**NOTICE OF A REGULAR
PLANNING COMMISSION MEETING
October 7, 2026, at 7:00 PM**

Agenda Item: PLAN26-0011 Site Plan Application - Minor Amendment Orchards Phase 7

The Orchards Phase 7: Building 53

THE ORCHARDS AT HOMESTEAD
PHASE 7 & 8 - BUILDING 59
VINYARD UTAH

LEVEL 3 FLOOR PLAN OPTION 2
1/4" = 1'-0"

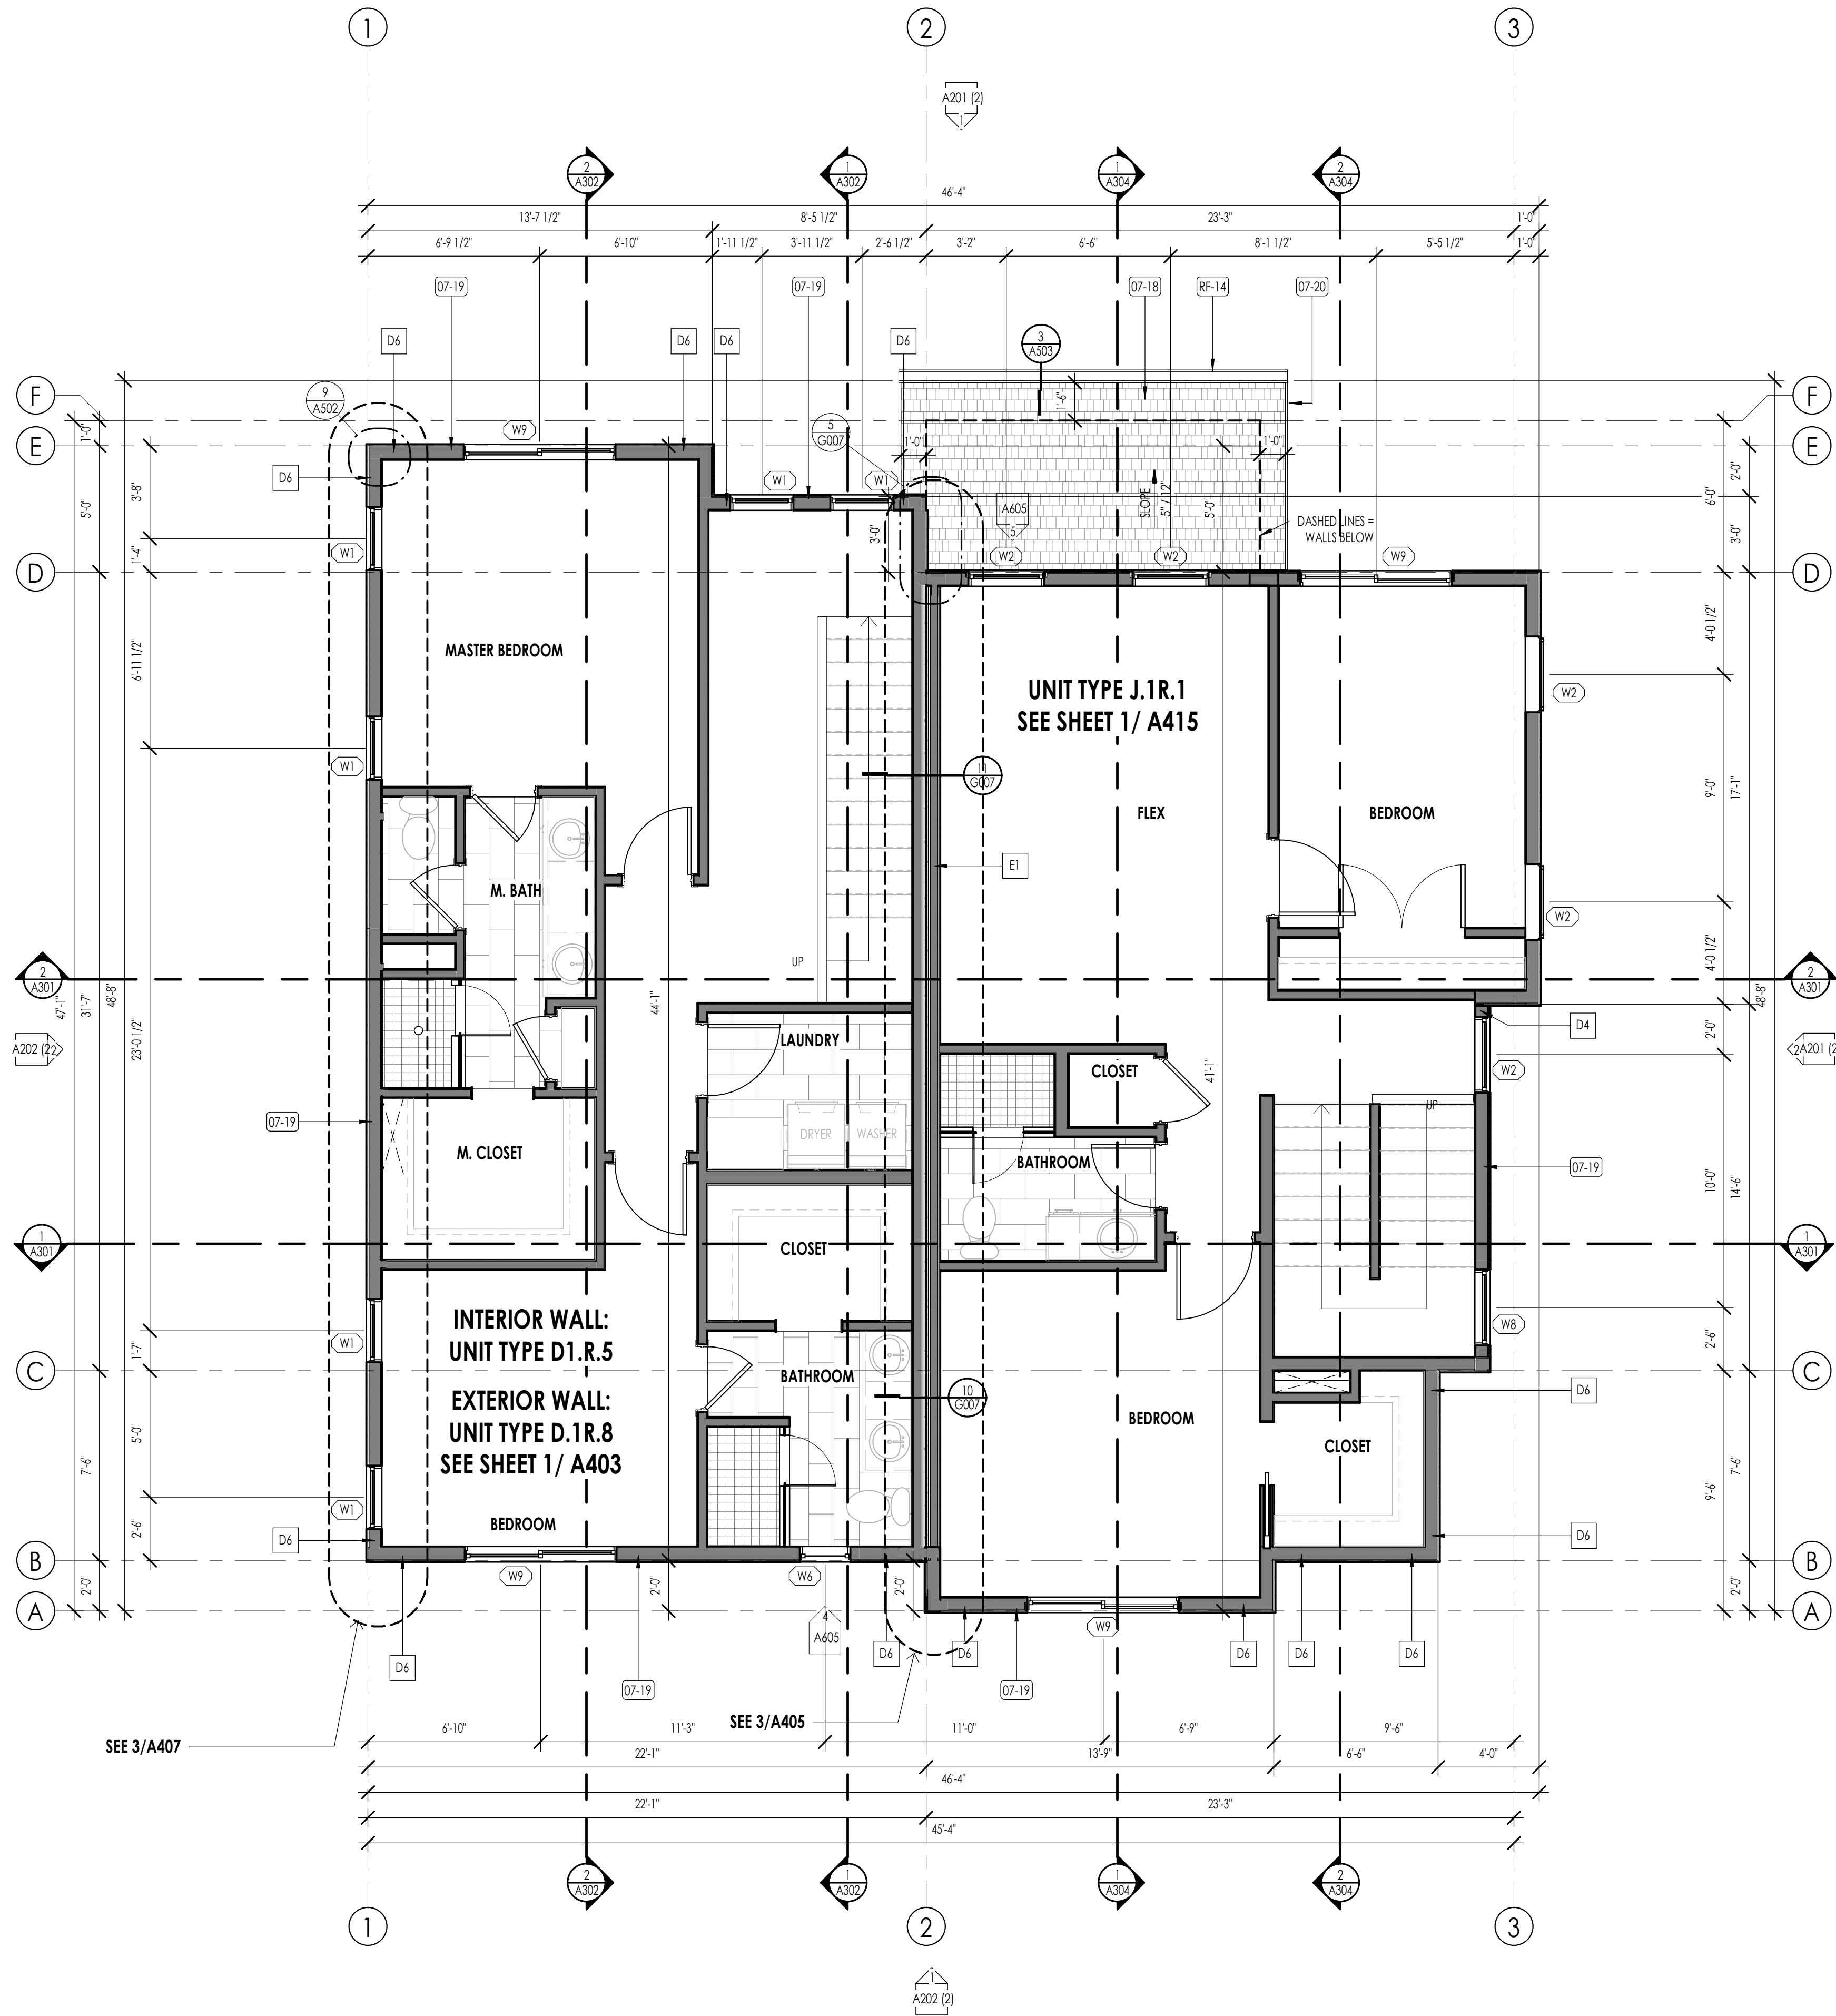
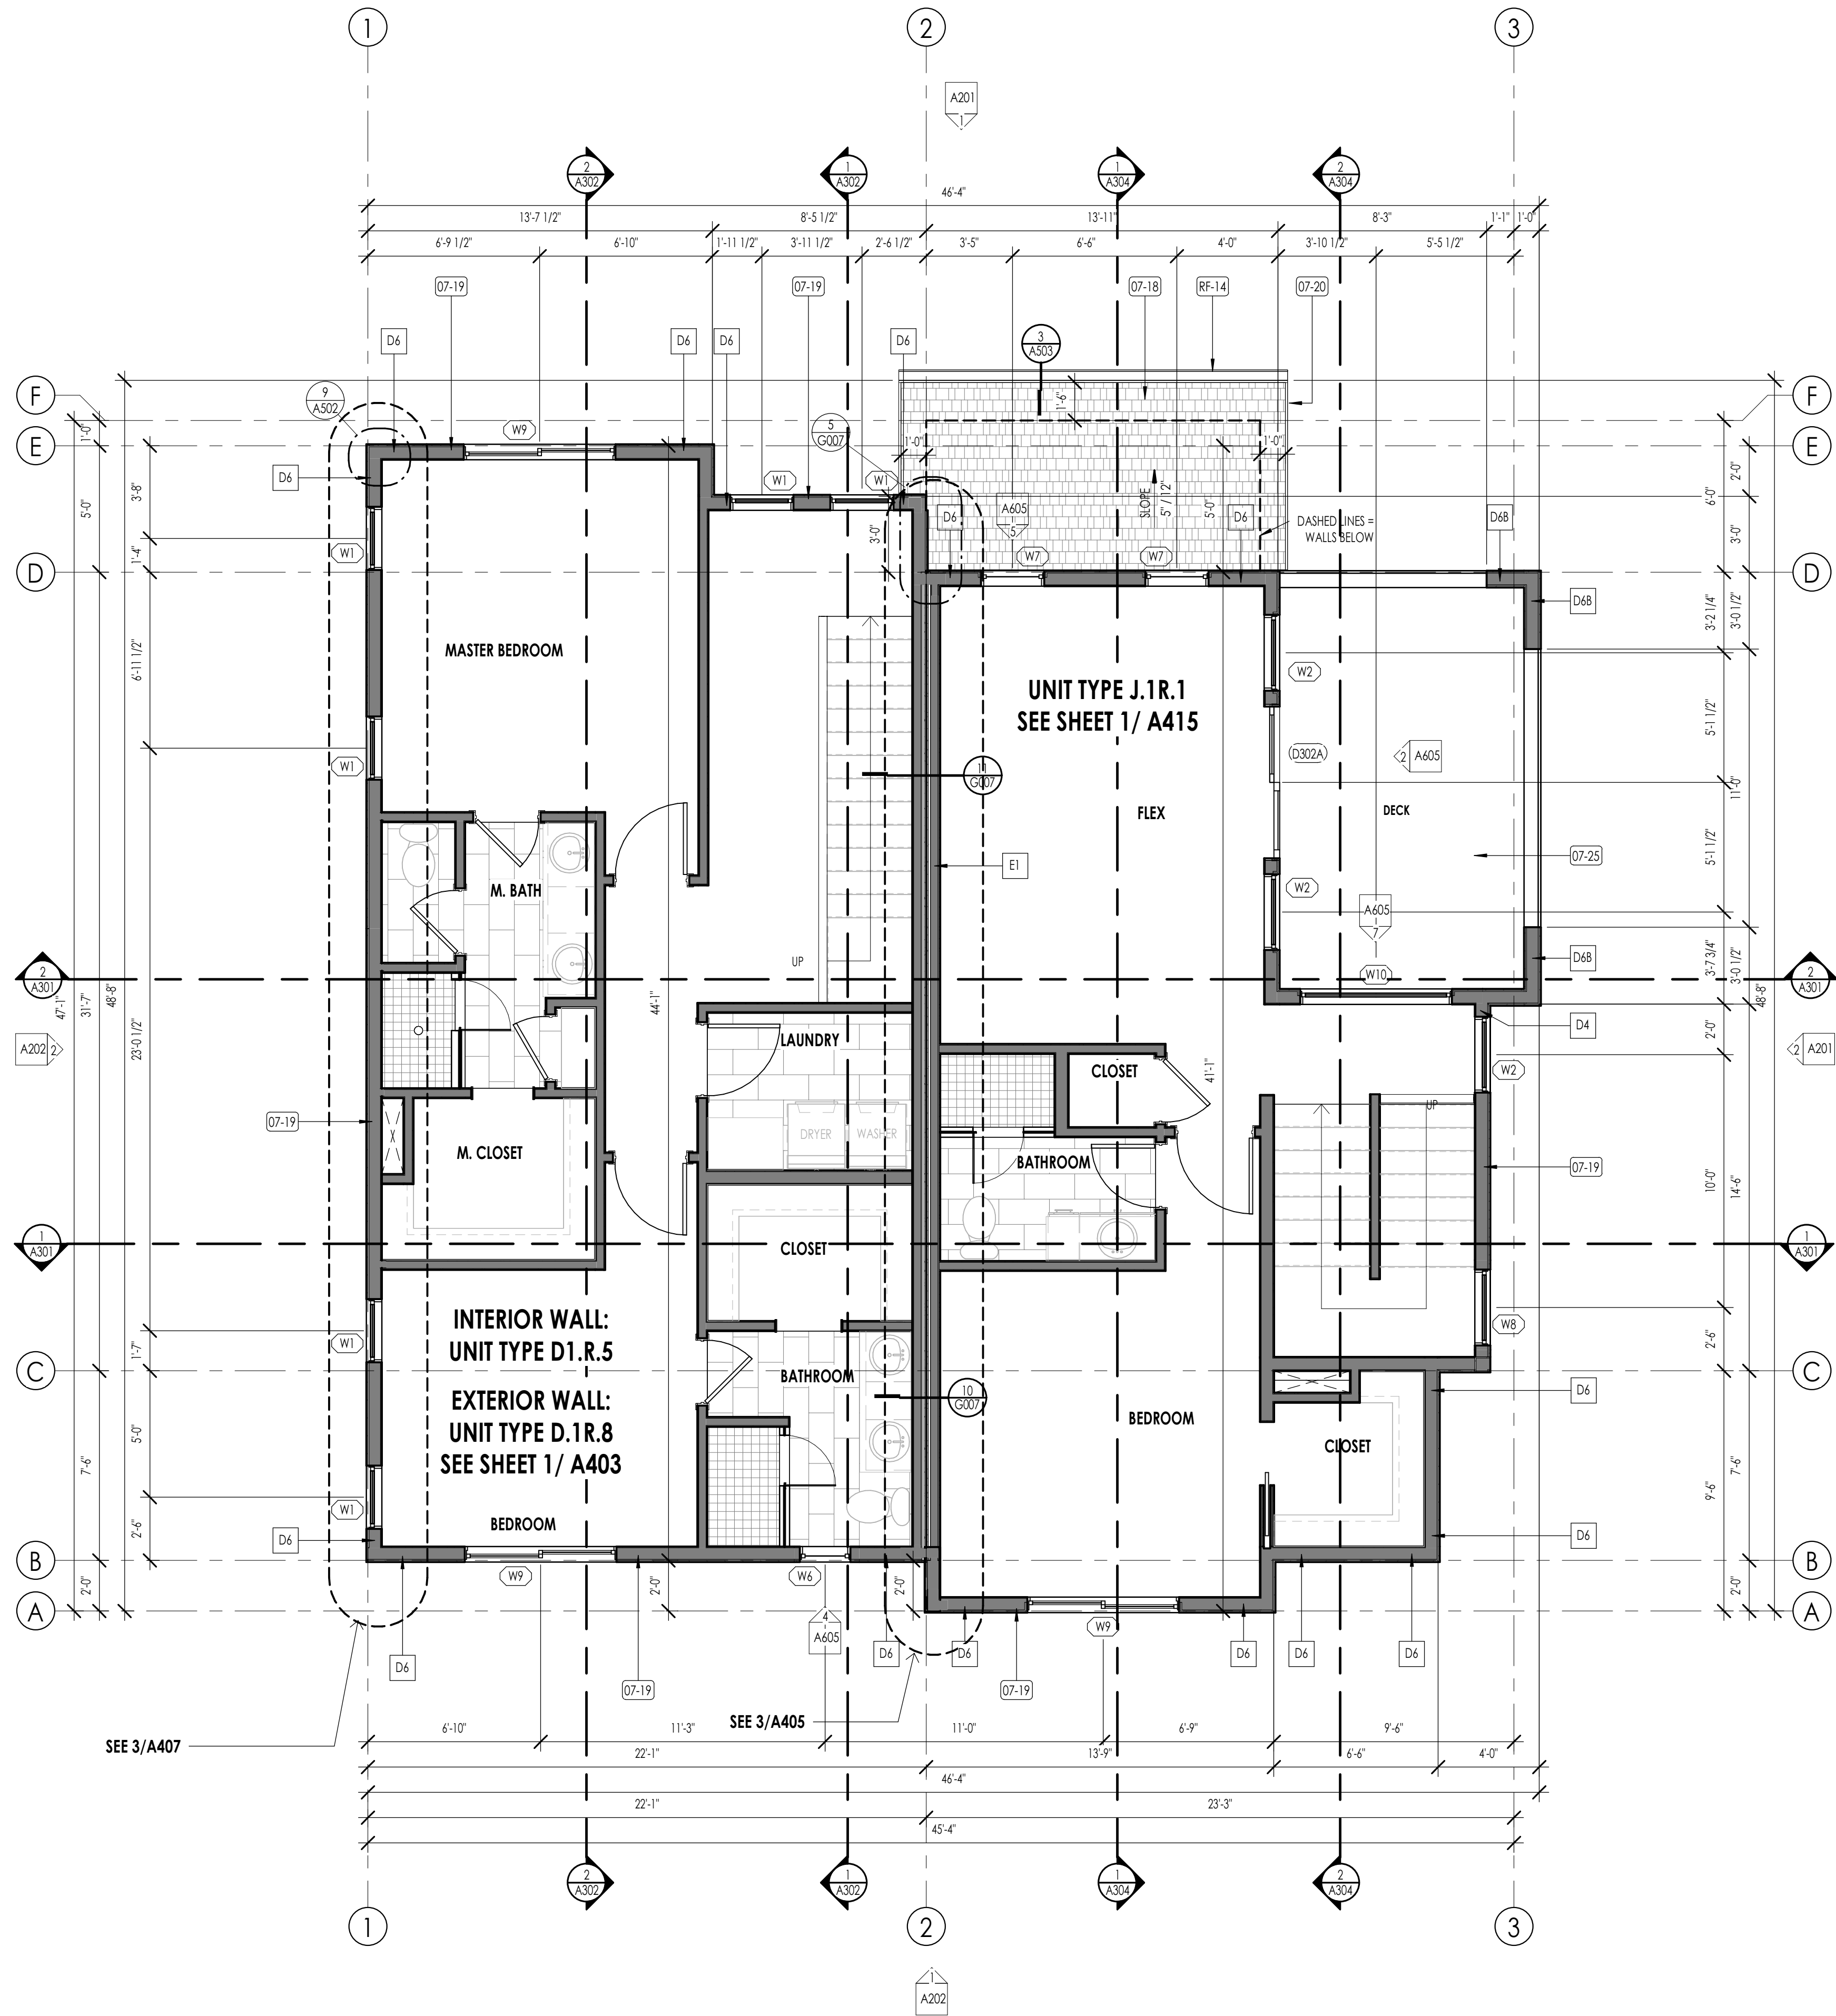
- The Two Units affected are the Unit K and Unit J only.
- The change was to infill the openings around the deck which has been converted into a bedroom. The room is now enclosed, with windows installed in the locations where the deck openings were previously located.
- The exterior siding and roof remain unchanged.
- For Unit Type D, the Level 2 deck has been revised to include a opening in the original brick wall with a railing, providing improved visibility and light to the interior while allowing for more positive deck drainage.
- The storefront color has been changed from dark bronze to white to maintain consistency with the other buildings throughout the development.
